REPORT TO COUNCIL

Application: DP17-0191 & DVP17-0192

Address: 289 Queensway Ave

Subject: Development Permit & Development Variance Permit Application

Figure 1: Kelowna Tall Building Comparison Chart

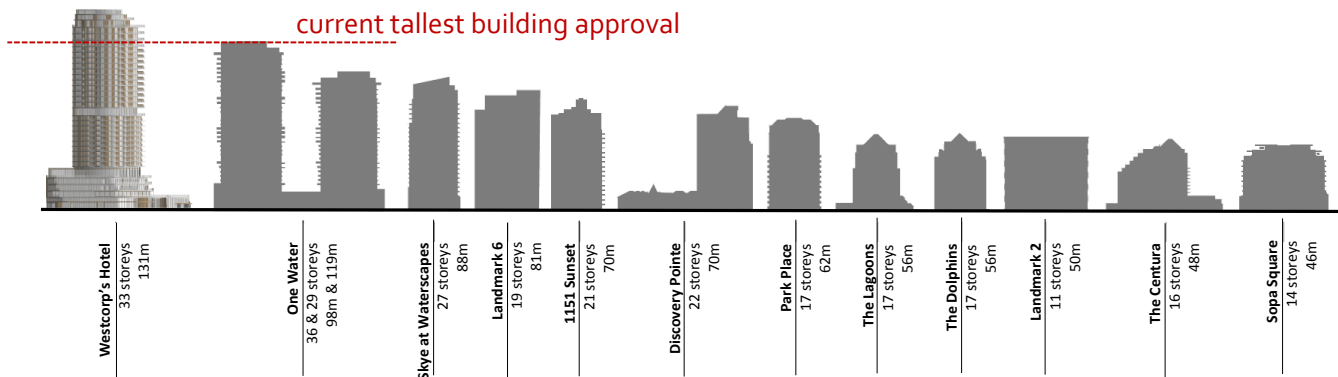
However, of more significance and weight, the applicant is proposing a height variance from 76.5m (26 storeys) as outlined in the Zoning Bylaw to 131m (33 storeys). The height variance and its impact is further accentuated by relatively large tower floor areas (i.e. width of the tower) and two further variances for the six-storey podium structure. It has never been the City's intention to achieve the region's tallest tower on this property and public policy states that contextual fit with the surrounding public realm and neighbouring buildings are of utmost importance.

Figure 3: Comparison of Tower Floor Plates between Previous 2014 Development Permit & Current Proposal

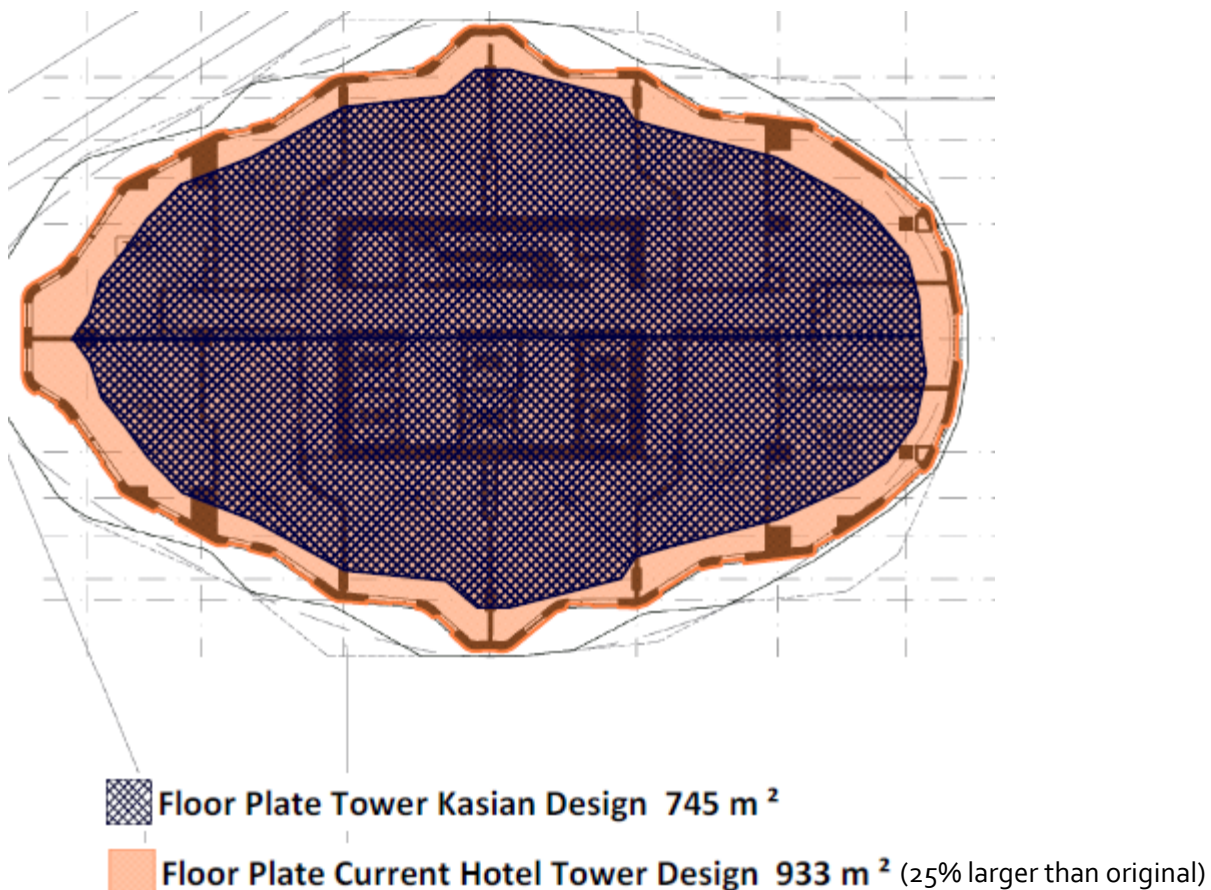
The tower floor areas, known as the 'floorplate' has increased significantly from the applicant's previous 2014 approved Development Permit. The past floorplate was 745 m² and the applicant's proposed floorplates are 933.0 m², 901.3m², & 833.1m². Staff remain concerned regarding the proposed new floorplates sizes as it directly relates to the buildings' overall massing and scale. The preference, consistent with many other Canadian urban centres, is to have floorplates for tall buildings within the range of 650 to 750 m². This would lead to the creation of a more slender tower form minimizing the building's three-dimensional massing and scale, helping to mitigate visual/physical impact on surrounding streets, parks, open spaces and neighbouring properties.

1. Reduction in the tower floor areas to achieve a more slender form; this would reduce massing and visual impact and help to reduce shadowing on neighbouring properties and the public realm.
2. Reduction in podium height especially on Water Street in order to provide a consistent streetscape experience and better transition to neighbouring buildings; and
3. Reduction in overall height would provide a more context sensitive development consistent with public policy and land use governance direction.

Figure 5: Proposed podium height along Water Street in relationship to neighbouring buildings

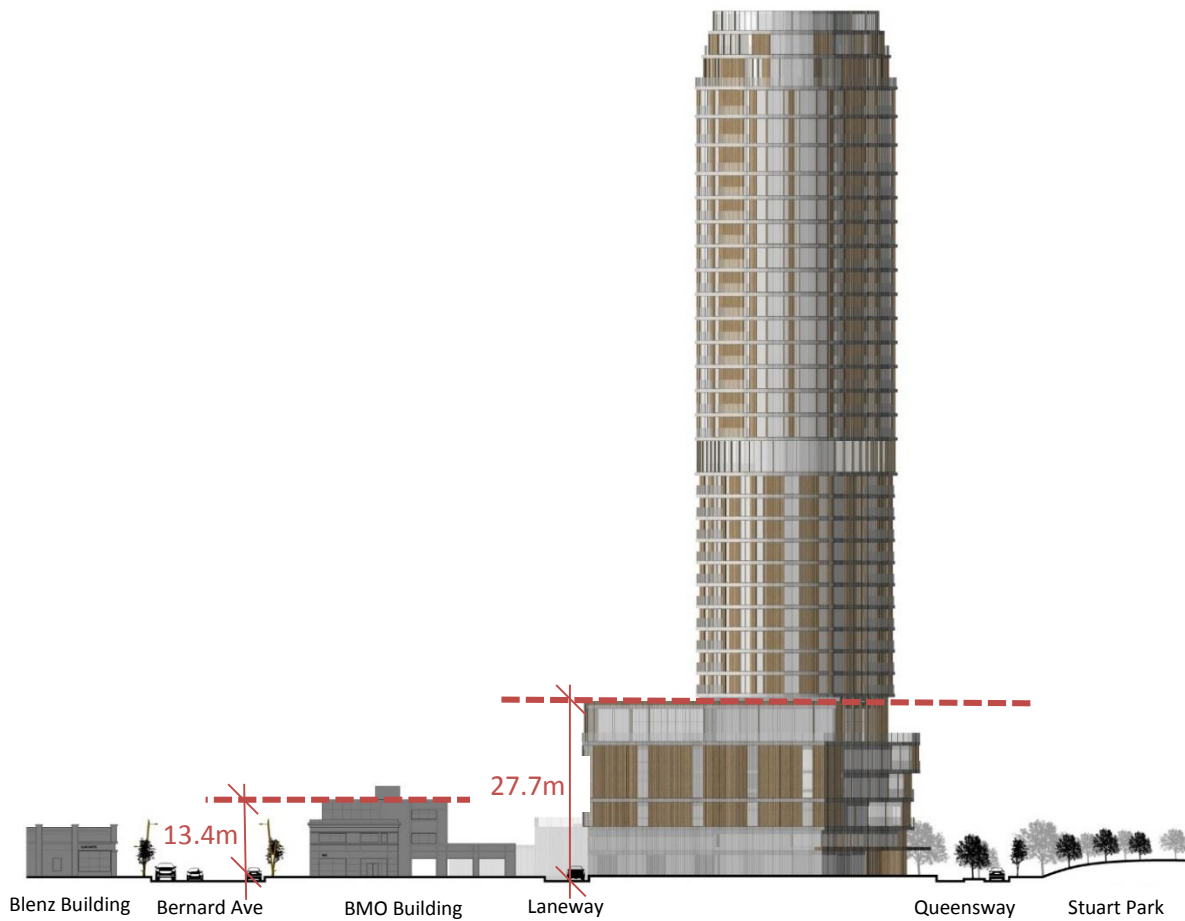
However, the two proposed variances related to the podium indicate the overall size and massing is large on the eastern elevation along the Water Street frontage. The total height of the podium facing Water Street is 27.7 m and the height of the podium before a 3m stepback is 19.2m. Creating a streetwall and podium that is too tall and large and will dominate the public realm; decreasing the pedestrian human-scale at street level. The adjacent building (BMO Bank) is 3 storeys (13.7 m in height) which makes the applicant's podium design more than double the size. Further, the other neighbouring buildings on Water Street and the heritage and historical character of Bernard Avenue are even lower at 2 storeys and protected from tall building development through the Downtown Height Map. The proposed podium does not step down or provide a sensitive transition to these existing buildings. It would create inconsistency in street proportion and scale and compromises reasonable sunlight exposure and sky views from the sidewalks. Staff would suggest aligning the podium height more in keeping with the existing buildings to create a consistent streetwall along Water Street resulting in a more comfortable urban environment.

Figure 6: Comparison of current proposal to past version of the project

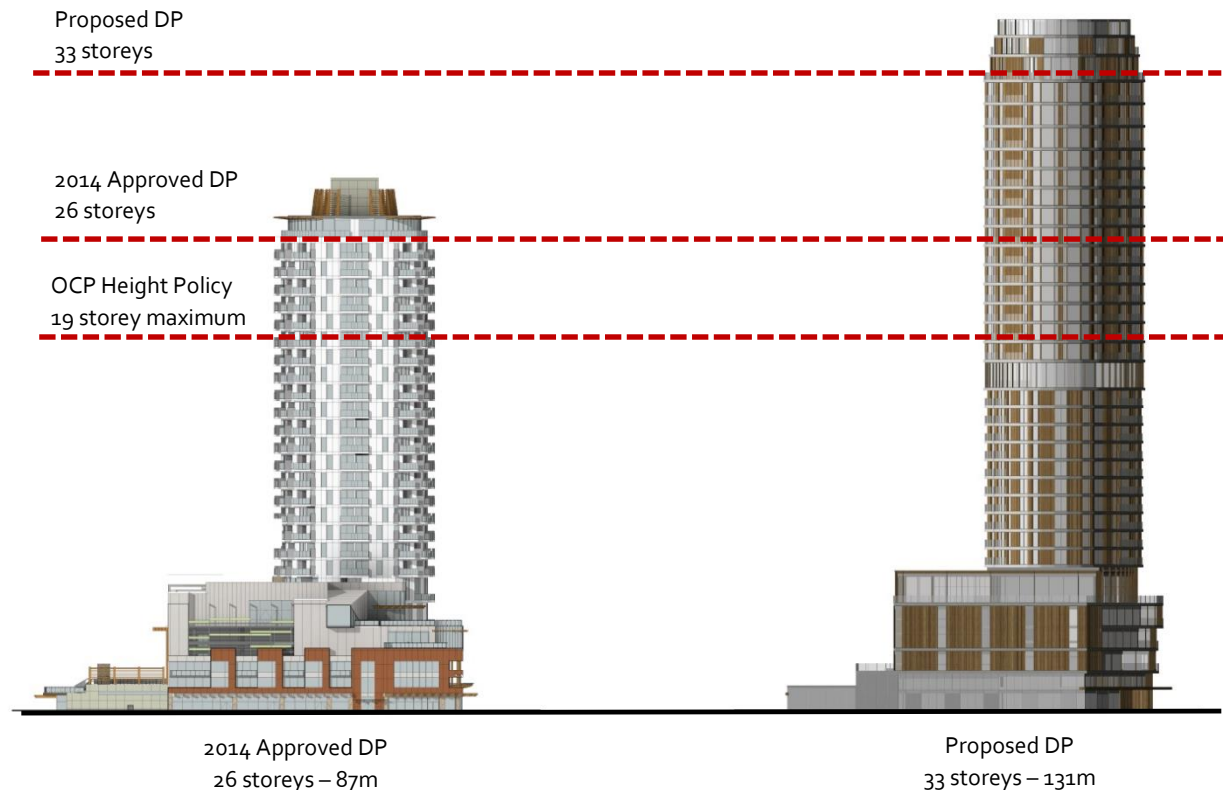
Summary of Differences in Project Proposals		
CRITERIA	Previous Proposal	Current Proposal
Height	26 storeys / 88m	33 storeys / 131m*
FAR	5.4	7.63
No. of Units	187 hotel rooms and 27 long-stay rental units (214 units total)	174 hotel rooms and 40 residences (214 units total)
Tower Floorplates	745 m ²	933 m ²
Parking	237 parking stalls in above-grade parkade (+5 surface stalls)	289 parking stalls (majority in two levels underground) +5 surface stalls
Tenants along Kerry Park	Restaurant and coffee shop on the edge of Kerry Park	no change from previous project
Hotel	Hotel's hospitality suite and hotel pool located on the conference level -conference terraces were "shared" with hotel guests	Hotel's hospitality suite and pool terrace are on the 2nd level of the hotel. The conference level terraces (level 6) will be for exclusive use of conference/event attendees
Tower & Parkade Location	Tower was located at the Kerry Park property line because of large parkade structure that needed to fit behind it	The tower is pulled back toward Water St. This is made possible because the above-grade parking structure is significantly smaller. The tower relocation has allowed the design of terraces that step up from the lake and park

Balconies & Terraces	Room balconies were appropriately sized for hotel rooms and affixed to the exterior of the structure	Large terraces are an integral part of each floor slab. The residential terraces are expansive and include outdoor kitchens
Elevators	The hotel tower serviced by 3 elevators	The tower is serviced by 6 elevators, 3 for the hotel rooms, conference level and 17th floor restaurant, 2 for the residences, and one for service purposes. With 2 additional elevators to the conference level, the total number of elevators servicing the conference level is 5
Retail	Retail opportunities located on Water St. side of the building	Retail opportunities are located on both Water St. and within the hotel lobby
Tower Restaurant	No mid-tower restaurant	The project includes a 17th floor publically accessible restaurant as well as a culinary teaching venue
*The current design's floor slab thickness is also a factor in the increased height. Each of the floor slabs of the new tower will be 4" thicker than in the previous proposal. Increased ceiling heights and floor slab thickness account for 16.5m (38%) of the height increase
